Access Compliance Report

Public Rights-of-Way

Intersection ID: 5500	Main Street: NORTHWOODS_FOREST_DR	Cross Street: SUGAR_HOLLOW_DR	Location:	N
ADA ID: 11AA0131CFBE	Ramp Type: Perp	Initial Pass/Fail: Fail	Overall Compliance: No	Severity Score: 12.5
Codes/Mitigation Info/Possible Solution		Field Measurements/Component Compliance

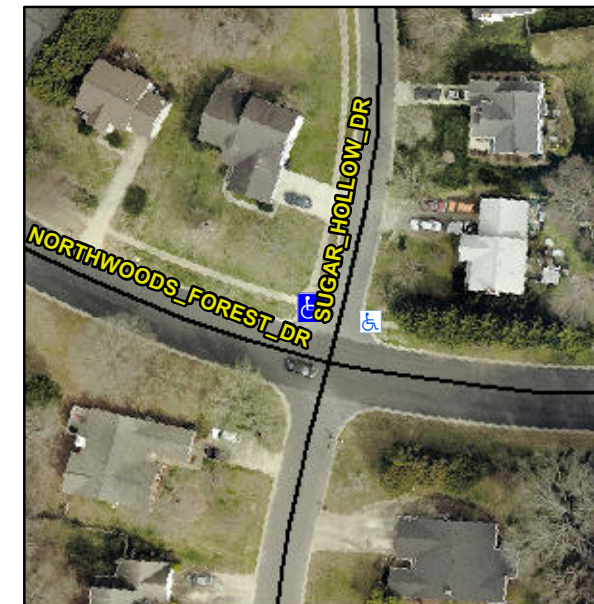
Not Found, R304.2.2

Compliance	Description	Data	Compliance	Description	Data
N/A	Ramp Length (in)	105.0	No	Ramp Slope (%)	8.4
Yes	Ramp Width (in)	61.5	Yes	Ramp XSlope (%)	1.3
N/A	Flare Type LT	N/A	N/A	Flare Type RT	N/A
N/A	Flare Slope LT (%)	N/A	N/A	Flare Slope RT (%)	N/A
N/A	Flare Traversable LT?	N/A	N/A	Flare Traversable RT?	N/A
N/A	Landing Length (in)	N/A	N/A	DWS Provided?	N/A
N/A	Landing Width (in)	N/A	N/A	DWS Contrast?	N/A
N/A	Landing Slope (%)	N/A	N/A	DWS Length (in)	N/A
N/A	Landing X Slope (%)	N/A	N/A	DWS Full Width?	N/A
N/A	Landing Curb? (Y/N)	N/A	N/A	DWS Offset (in)	N/A
N/A	Shared Landing?	N/A			
N/A	Gutter Ponding?	N/A	N/A	Gutter Slope (%)	N/A
N/A	Gutter Lip Ht (in)	N/A	N/A	Gutter X Slope (%)	N/A
N/A	Painted X Walk1?	No	N/A	Painted X Walk2?	N/A
	X Walk 1 Direction	To SE		X Walk 2 Direction	N/A
N/A	X Walk 1 Width (in)	N/A	N/A	X Walk 2 Width (in)	N/A
	X Walk 1 Slope (%)	1.0		X Walk 2 Slope (%)	N/A
	X Walk 1 X Slope (%)	0.8		X Walk 2 X Slope (%)	N/A

Remove & Replace Entire Ramp.
